INTERIM AMENDMENT

FEDERAL SPECIFICATION

CHISEL, BRICK

The General Services Administration has authorized the use of this interim amendment as a valid exception to Federal Specification GGG-C-315A, dated April 10, 1967.

FIGURE 1. Chisel, brick.

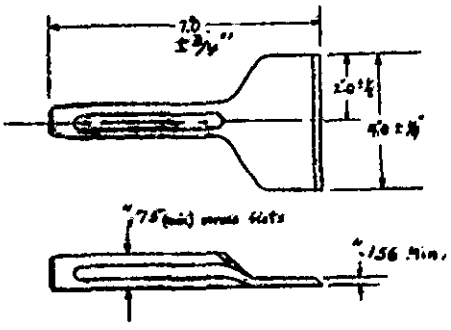
Delete figure 1 and substitute the following:
